# Access Compliance Report

## Public Rights-of-Way

### (Curb Ramps)

Intersection ID: 28347	Main Street: CASTLEBAY_DR	Cross Street: QUINTRELL_DR	Location: SW
ADA ID: F066BA2E60E1	Ramp Type: Perp	Initial Pass/Fail: Fail	Overall Compliance: No
Codes/Mitigation Info/Possible Solution		Field Measurements/Component Compliance	
Severity Score: 12.5

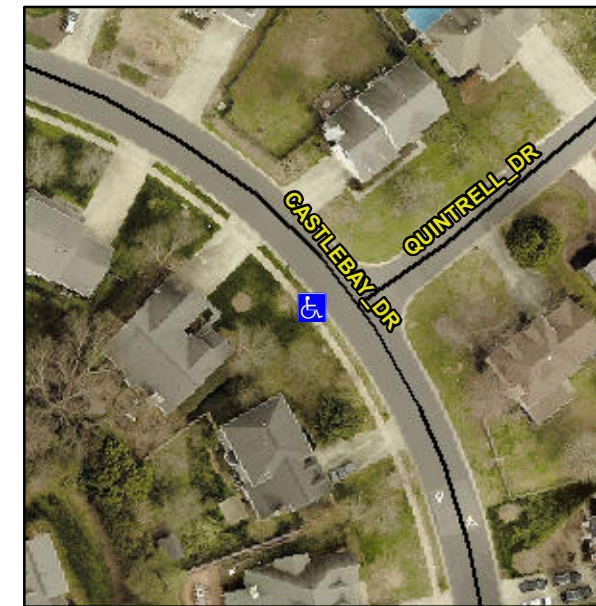
**Not Found, R304.2.2**

Compliance	Description	Data	Compliance	Description	Data
N/A	Ramp Length (in)	46.0	No	Ramp Slope (%)	9.1
Yes	Ramp Width (in)	71.0	Yes	Ramp XSlope (%)	0.1
N/A	Flare Type LT	N/A	N/A	Flare Type RT	N/A
N/A	Flare Slope LT (%)	N/A	N/A	Flare Slope RT (%)	N/A
N/A	Flare Traversable LT?	N/A	N/A	Flare Traversable RT?	N/A
N/A	Landing Length (in)	N/A	N/A	DWS Provided?	N/A
N/A	Landing Width (in)	N/A	N/A	DWS Contrast?	N/A
N/A	Landing Slope (%)	N/A	N/A	DWS Length (in)	N/A
N/A	Landing X Slope (%)	N/A	N/A	DWS Full Width?	N/A
N/A	Landing Curb? (Y/N)	N/A	N/A	DWS Offset (in)	N/A
N/A	Shared Landing?	N/A			
N/A	Gutter Ponding?	N/A	N/A	Gutter Slope (%)	N/A
N/A	Gutter Lip Ht (in)	N/A	N/A	Gutter X Slope (%)	N/A
N/A	Painted X Walk1?	No	N/A	Painted X Walk2?	N/A
	X Walk 1 Direction	To NE		X Walk 2 Direction	N/A
N/A	X Walk 1 Width (in)	N/A	N/A	X Walk 2 Width (in)	N/A
	X Walk 1 Slope (%)	3.5		X Walk 2 Slope (%)	N/A
	X Walk 1 X Slope (%)	0.4		X Walk 2 X Slope (%)	N/A

**Remove & Replace Entire Ramp.**
